City of El Paso – City Plan Commission Staff Report

Case No: SUSU12-00007 Rio Valley Subdivision
Application Type: Major Combination
CPC Hearing Date: March 8, 2012
Staff Planner: Justin Bass, (915) 541-4930, bassjd@elpasotexas.gov
Location: West of Westside Drive and North of Borderland Road
Acreage: 60.46 acres
Rep District: 1
Existing Use: Vacant
Existing Zoning: G-MU (General Mixed-use) & C-1 (Commercial)
Proposed Zoning: G-MU (General Mixed-use) & C-1 (Commercial)
Nearest Park: River Park West Unit Three Park (1.14 miles)
Nearest School: Garcia Elementary School (0.33 mile)
Park Fees Required: **\$5,850.00**
Impact Fee Area: This property is not located in an Impact Fee Service Area and not subject to impact fees.
Property Owner: Rio Valley, LLC
Applicant: Rio Valley, LLC
Representative: Summit Engineering

ATTACHMENT 5

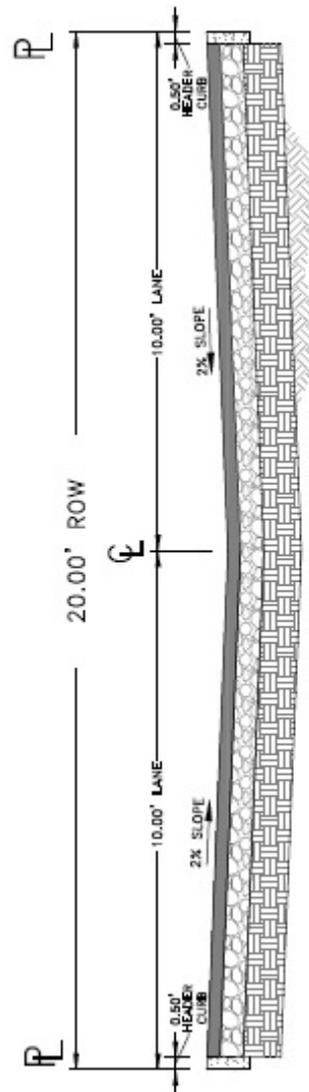
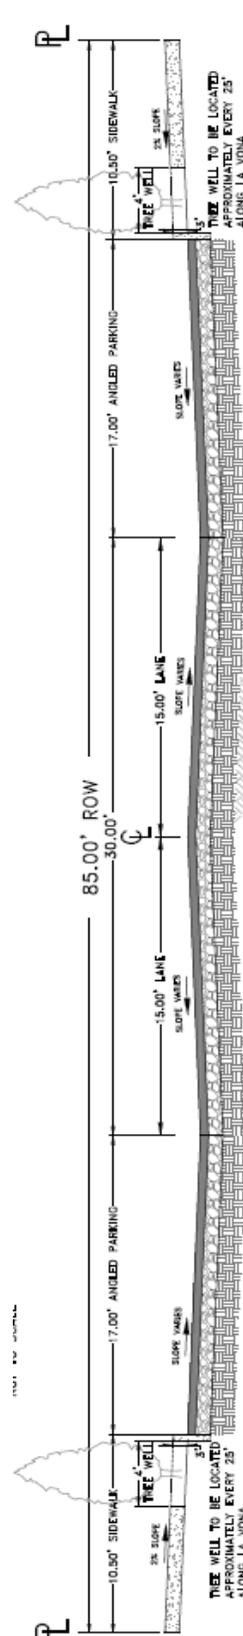
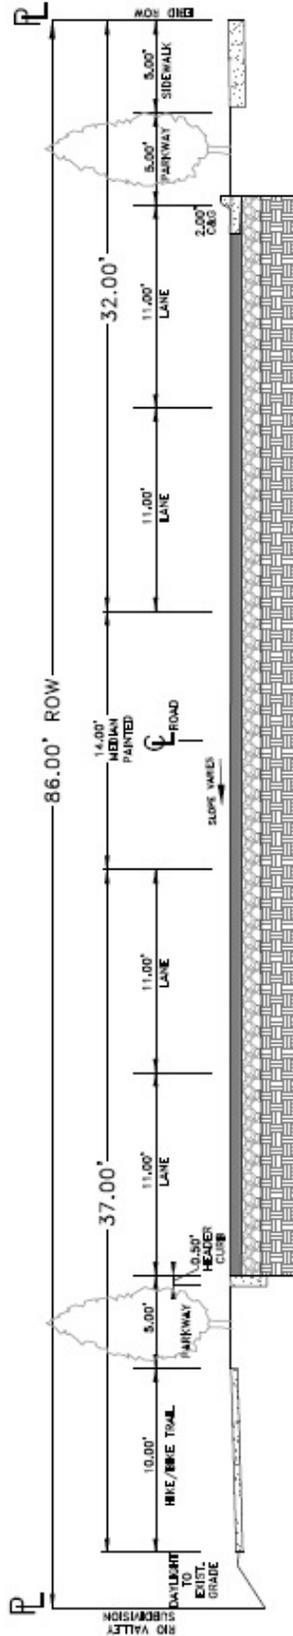
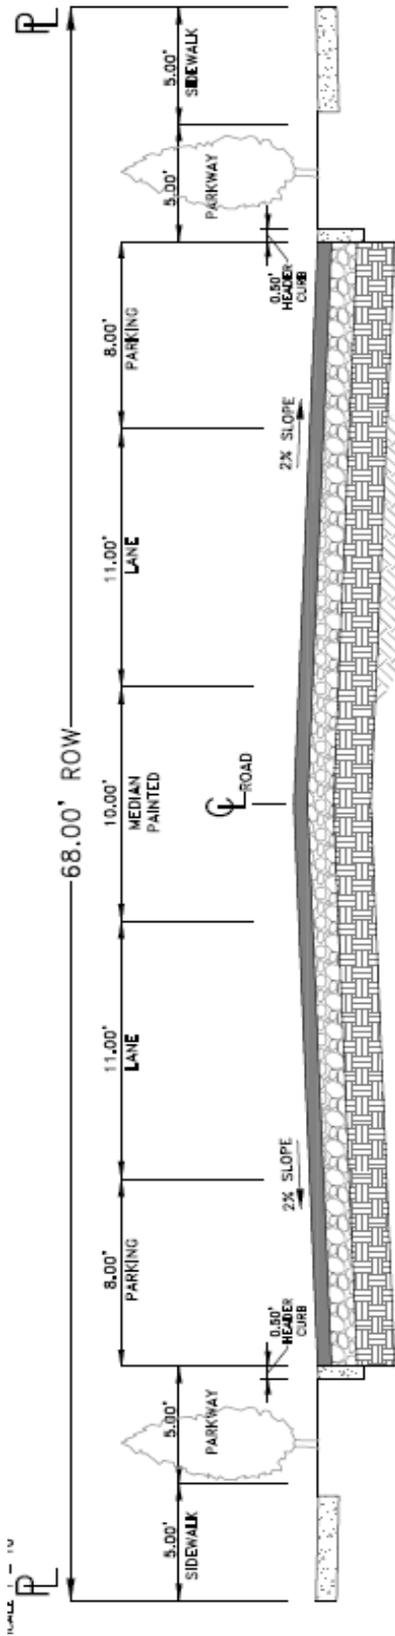
1. To allow for residential lots to abut a park within Blocks, 4, 5, and 8.
2. To allow for 20-ft alleys within Blocks 11, 13, and 14.
3. To allow for alternative roadway cross-sections on Westside Drive and Borderland Road.
 - Westside Drive will consist of an 86-ft right-of-way, to include 58-ft of pavement, a 10-ft hike/bike trail abutting the proposed development and a 5-ft sidewalk on the opposite side, and 5-ft parkways.
 - Borderland Road will consist of a 68-ft right-of-way, to include 48-ft of pavement, 5-ft sidewalks and 5-ft parkways on both sides of the road.

2. Transportation does not object to the proposed alternative designs proposed for the roadways in accordance with Section 19.26. (Alternative Subdivision/Smart Code Designs).
